APPENDIX E
GEOLOGY AND
WELL INFORMATION

**Gill Ranch Gas Storage Project
Second Supplement to the PEA:
Responses to Application Completeness/Data Needs Comments
Part 1: Project Description (Geology)**

8. **Submit the completed geotechnical reports describing the analysis of potential gas migration pathways, such as faults, permeable contacts, abandoned wells, underground water pipelines, or other pipelines. (Deficiency.)**

Figure 1
GILL RANCH - PRIMARY PRODUCTION
 East 1st STARKEY

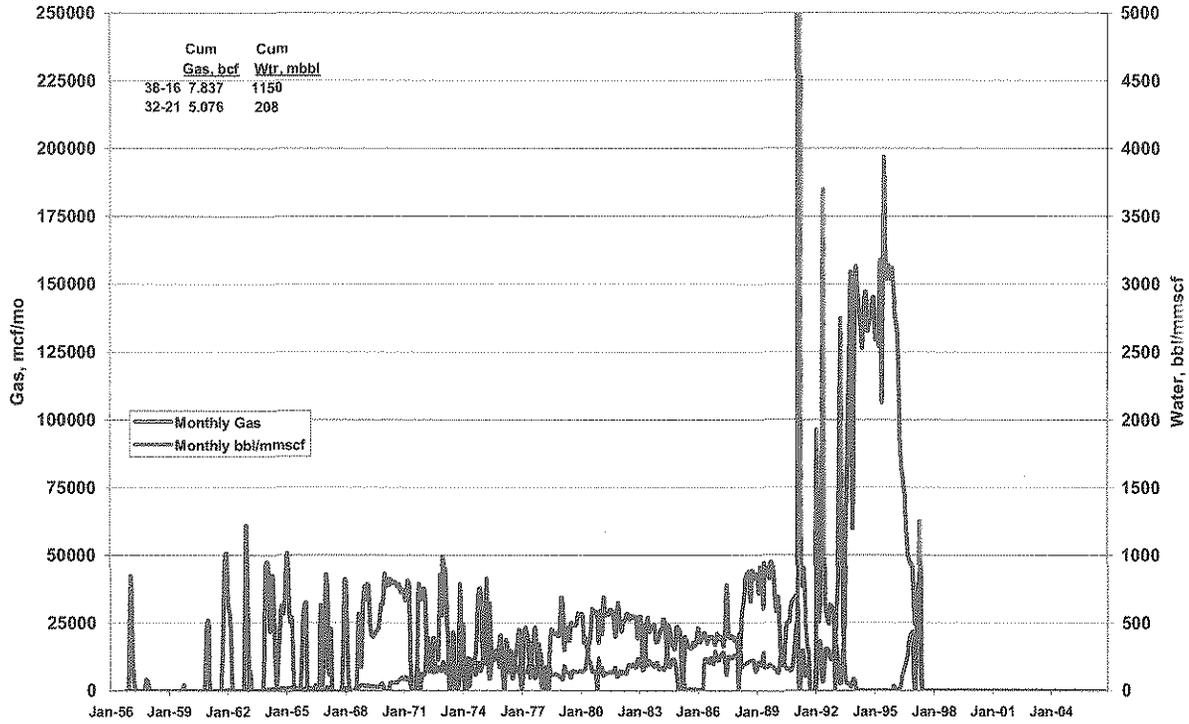
10. Provide a complete history of the gas field, including production and well histories. (Deficiency.)

Historical production data for each well was obtained from the California Division of Oil and Gas public data base. This was used to create production plots for each of the four reservoirs, which are shown as Figures 1 through 4. First reported production was in 1957. Wells were single reservoir completions. Production was not commingled during primary production.
